# Rate Base Procurement (RBP)

## Frequently Asked Questions (FAQ)

Updated: May 4, 2022

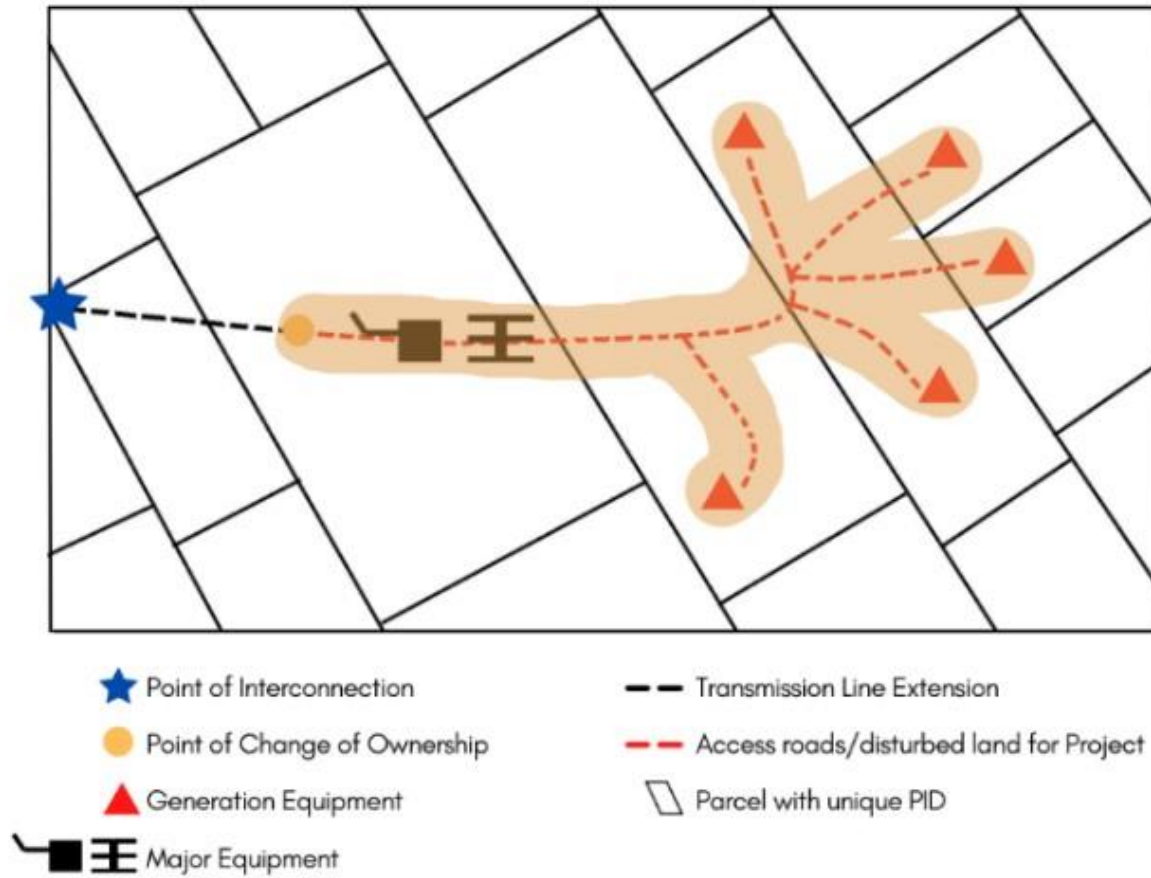
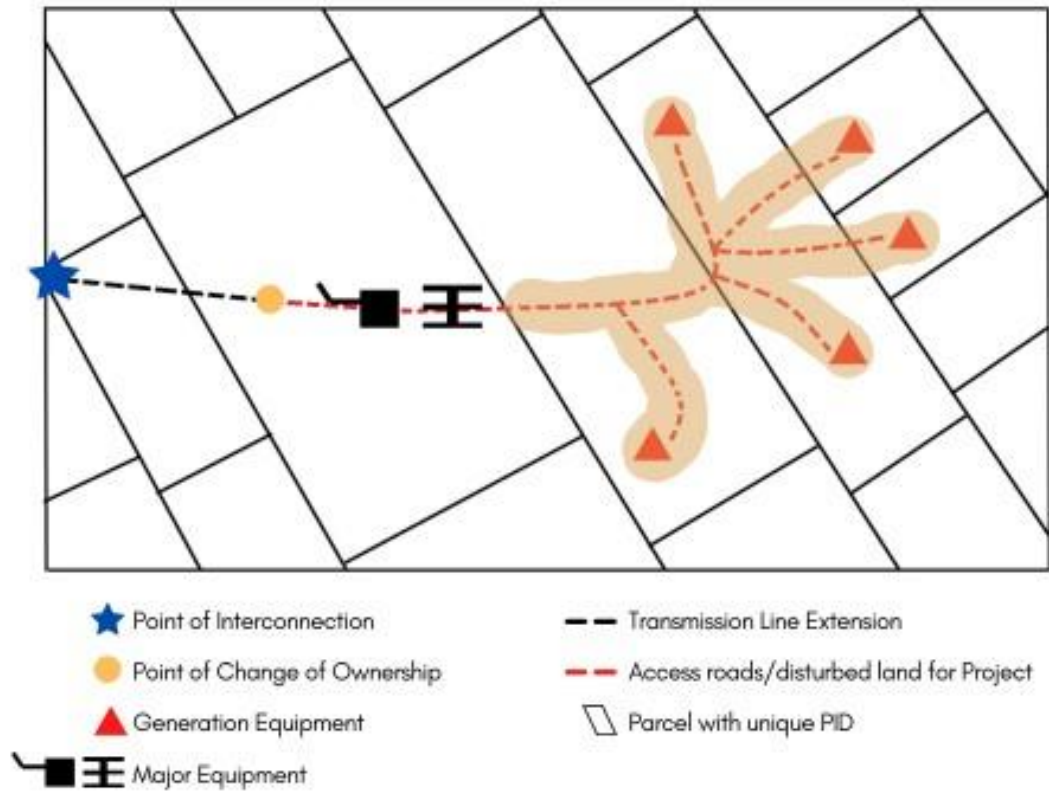
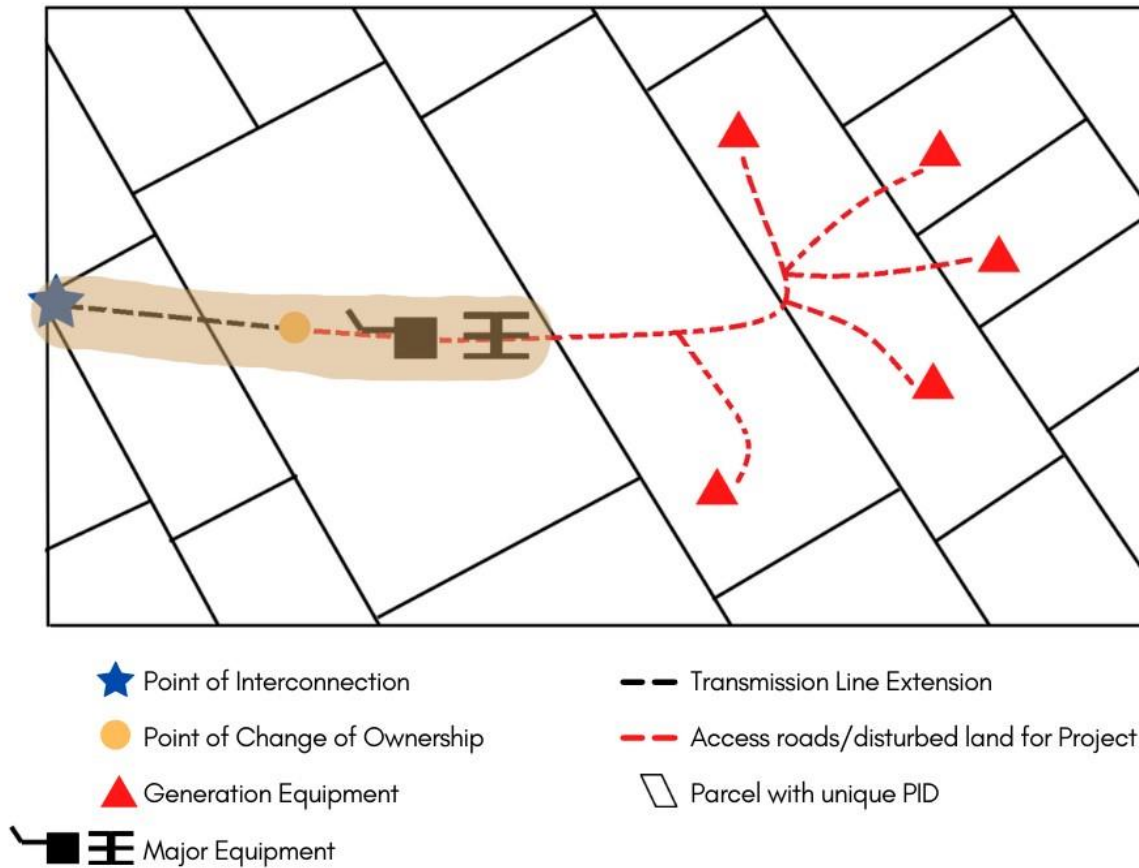
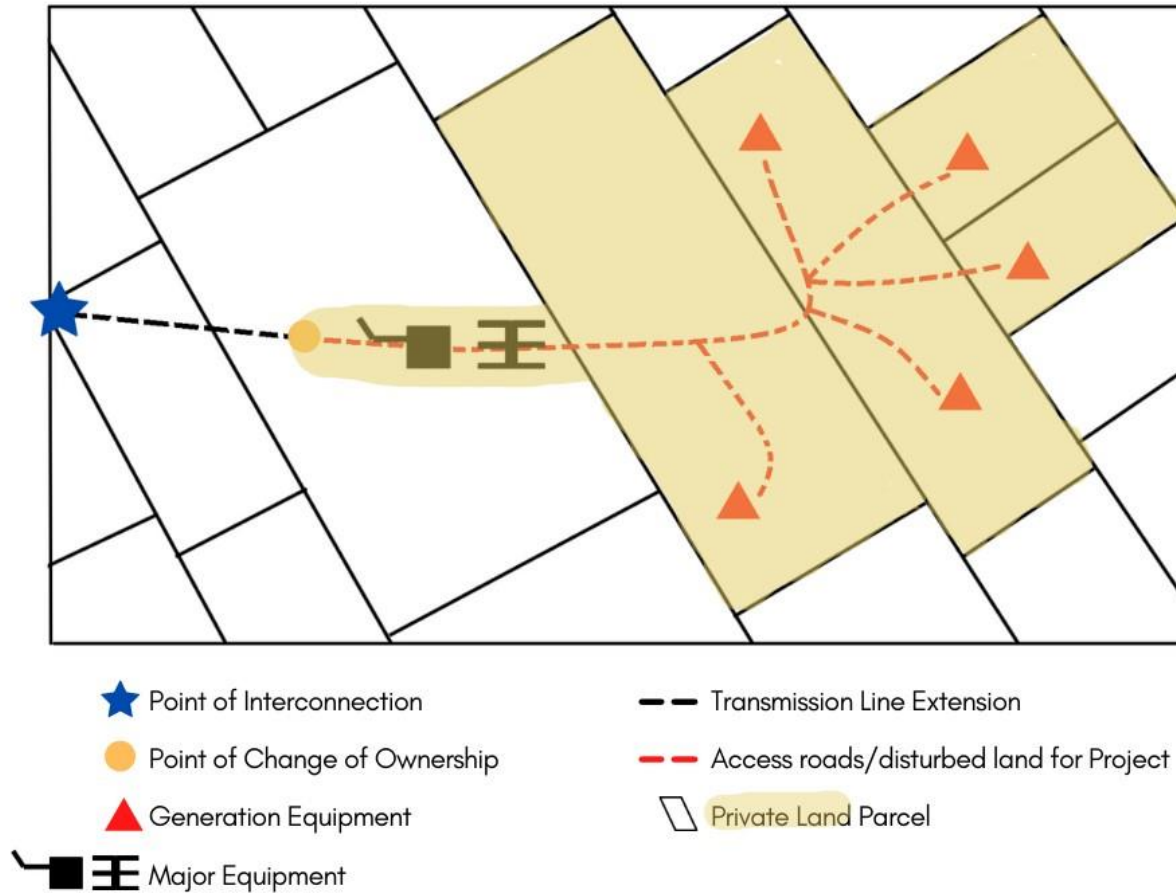
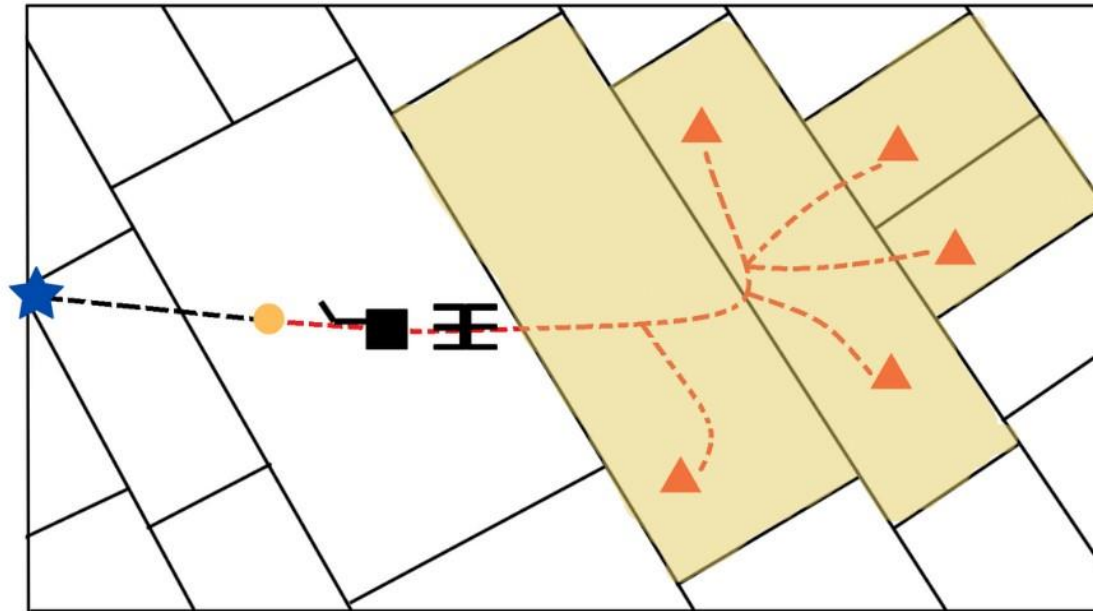
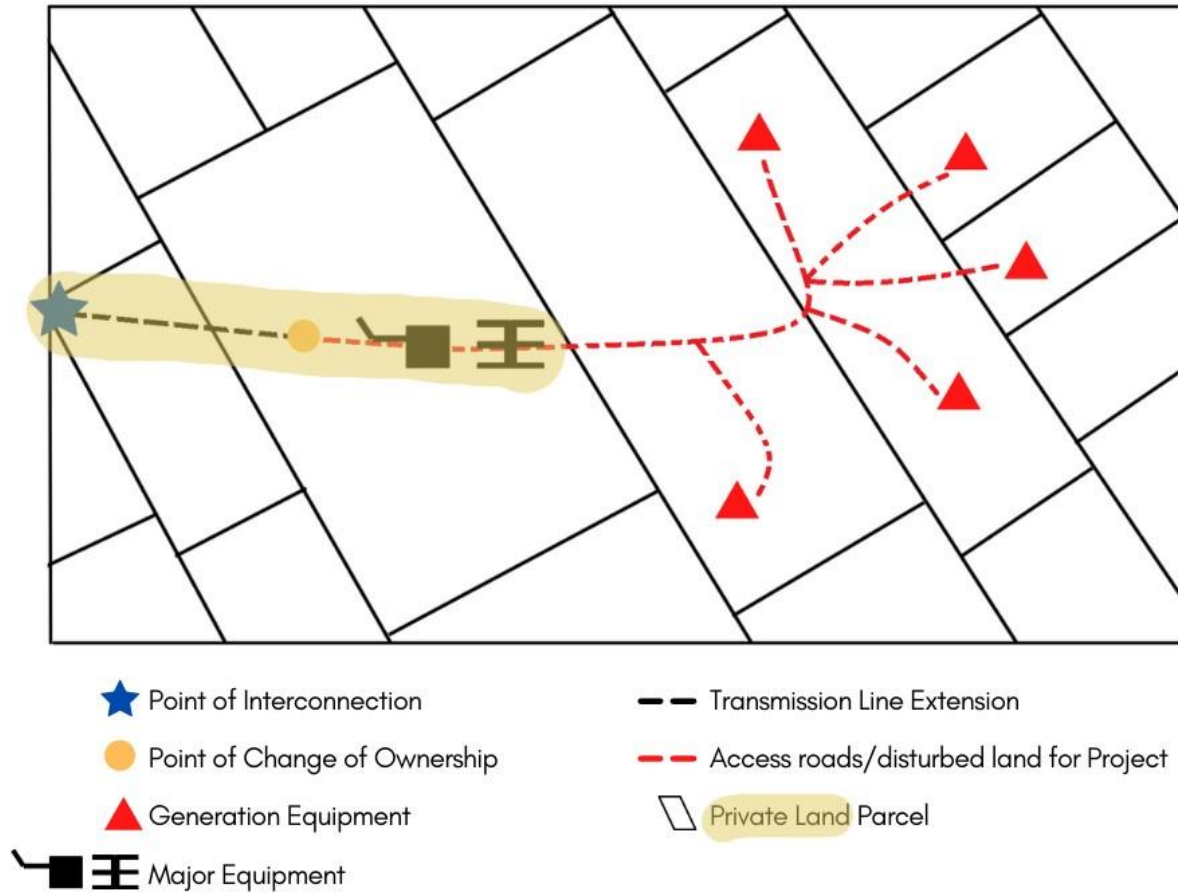
6.2.5 Project Site	<b>Can the PA clarify between the Project Site and Project Boundary?</b>	The PA has created graphics to visualize the difference between the Project Site and Project Boundary. See below this table for details.
